GEOLOGY AND SOILS REPORT

**Carriage Meadows South
El Paso County, Colorado**

**June 15, 2016
Amended June 29, 2016
Amended October 7, 2016**

Re: Response to
Colorado Geological Survey Review Comments
Carriage Meadows South at Lorson Ranch
El Paso County, Colorado

SHEET No.
FIG-22

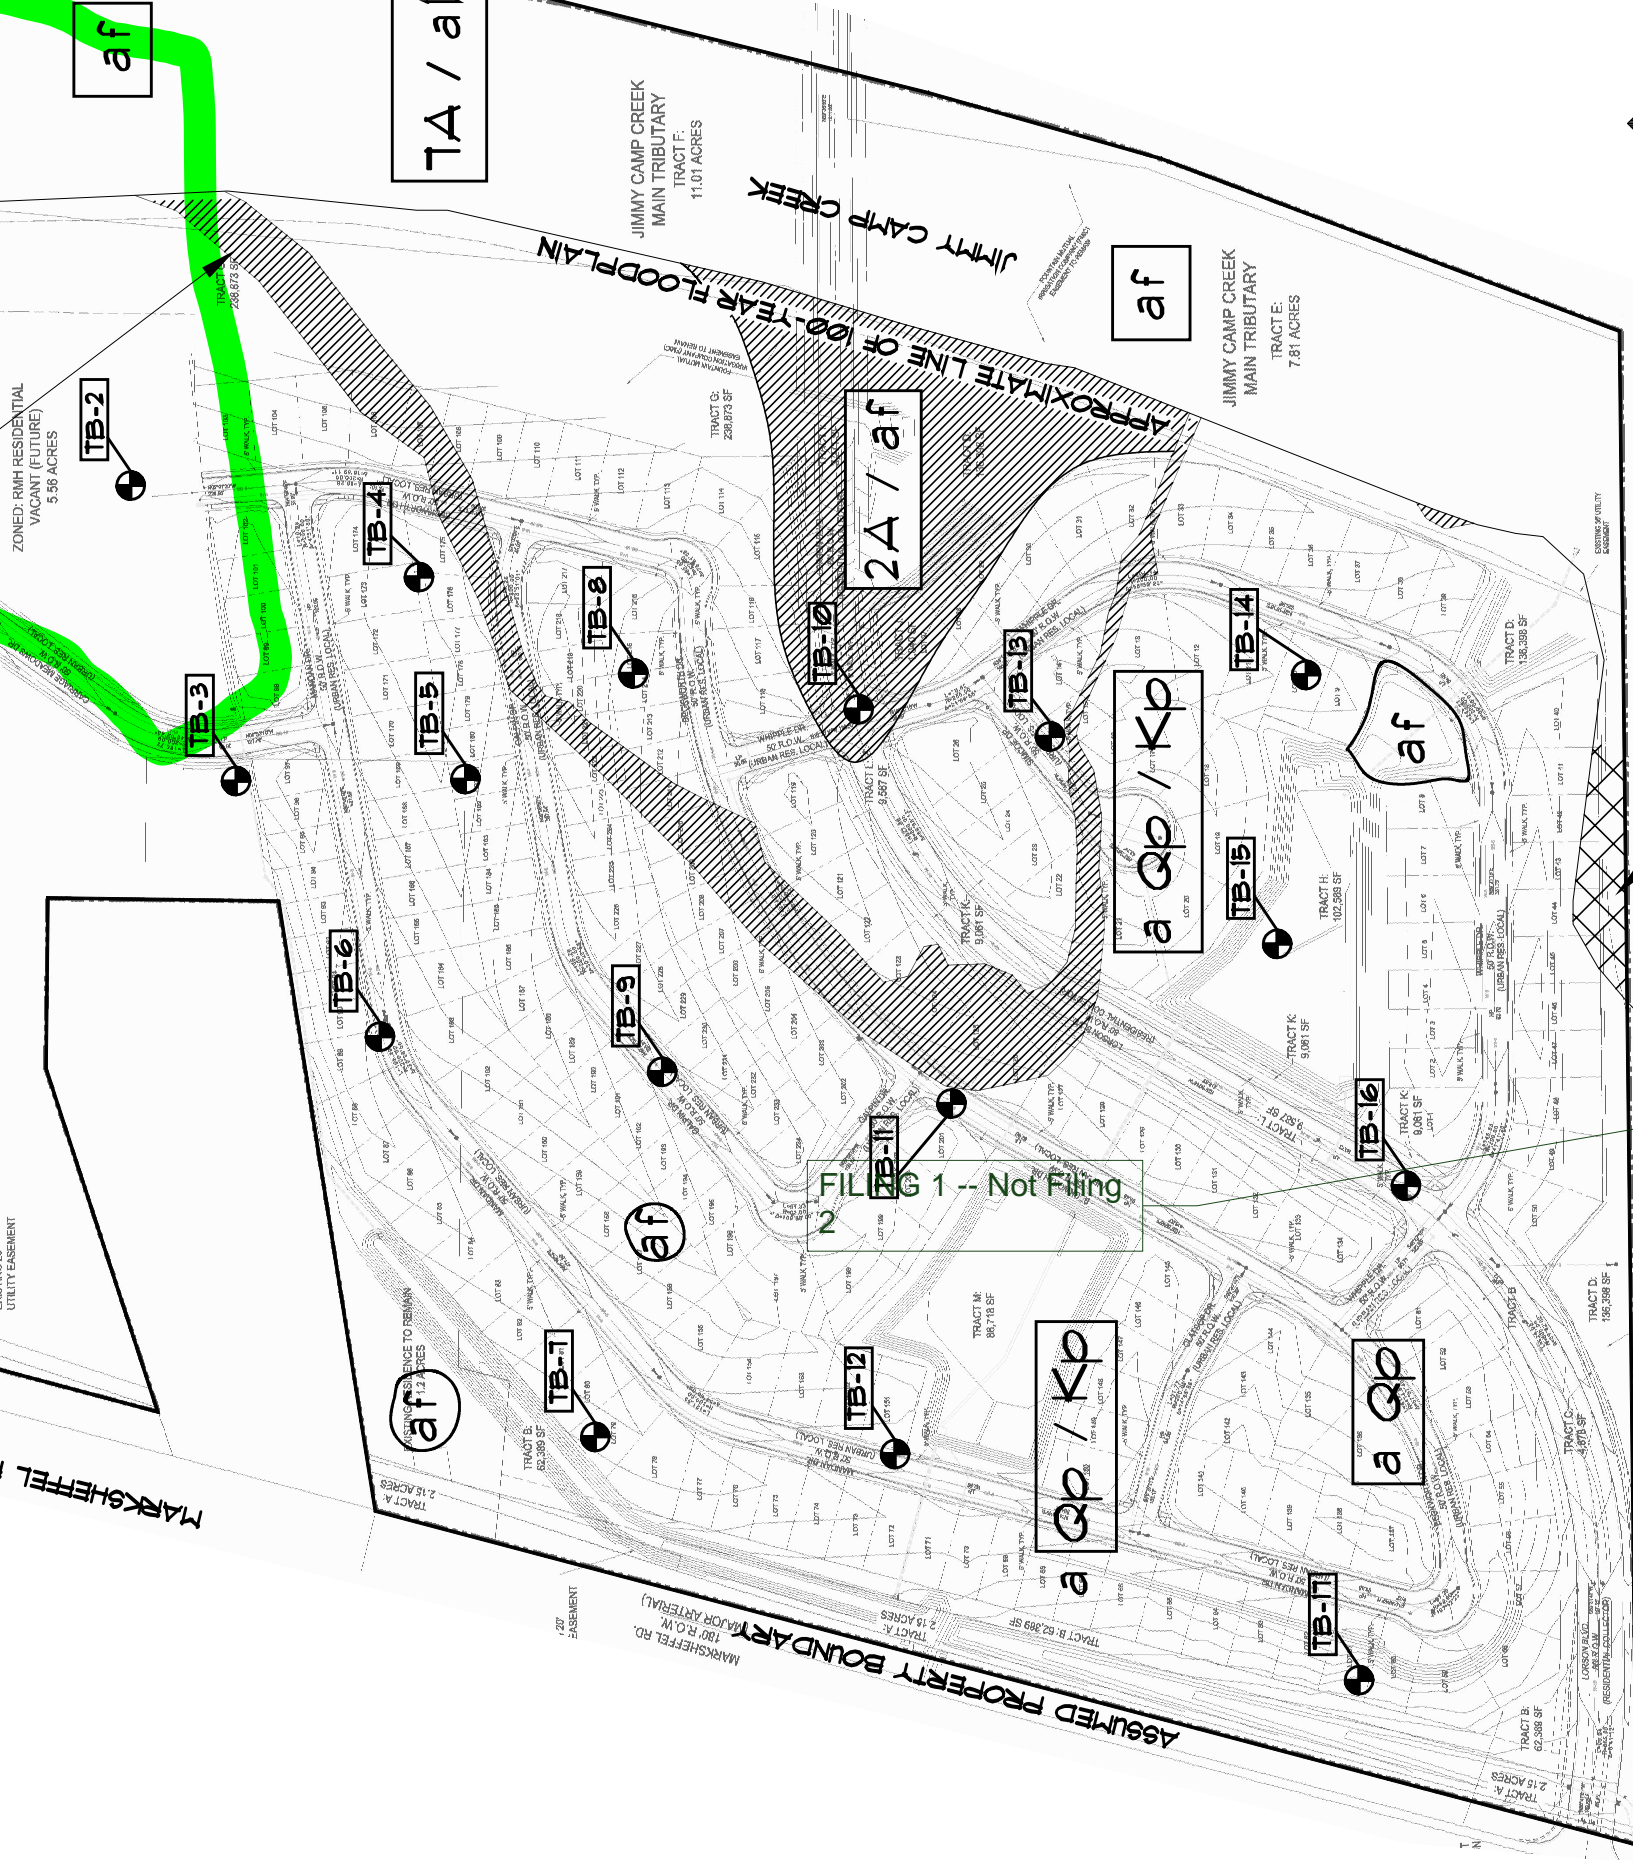
- **Comment:** *"Provide a map (or add to figure 22) of the hazards referenced in the report overlain by the preliminary plan. This will identify specific lots that are not suitable for basements, include artificial fill where structural fill was previously identified, expansive soils (no basements or shallow foundations) or may need underdrains or other mitigation techniques. Identify the floodplain and those lots or roads in said floodplain. Map the potential unstable slopes on this figure to clearly show no lots are proposed in these areas unless mitigation is proposed. Does the southeast portion of the site still have floodplain located on it? There are lots shown here. See Figure 23 revised FEMA map post LOMR). Should a test boring be completed in the area, nearest to the channel that may or may not be in the FEMA floodplain if lots are proposed near the channel and proposed drainage way?"*

where is the plan
identifying the
constraints and
hazards over top the
lot layout?

Provide detail

RMG Response: As noted above, it is our opinion that there is insufficient reason to preclude full-depth basements on any of the lots in this subdivision at this time. That determination shall be made based on conditions encountered in the lot-specific Subsurface Soil Investigation.

The areas of fill identified by Kumar and Associates have been added to Figure 22 of the amended report dated October 7, 2016. The approximate boundary of the 100-year floodplain has also been added to Figure 22 of the amended report dated October 7, 2016. This boundary does not intersect any of the proposed roads, but it does cross the southernmost portion of lots 40 through 45. It is not anticipated that there will be adequate separation between the floodplain and the proposed residences on lots 40 through 42 and 45. Additional care may be required on lots 43 and 44 to ensure that the residence does not encroach within the 100-year floodplain. These areas should be marked as "No Build" zones on the approved plat and/or development plans.
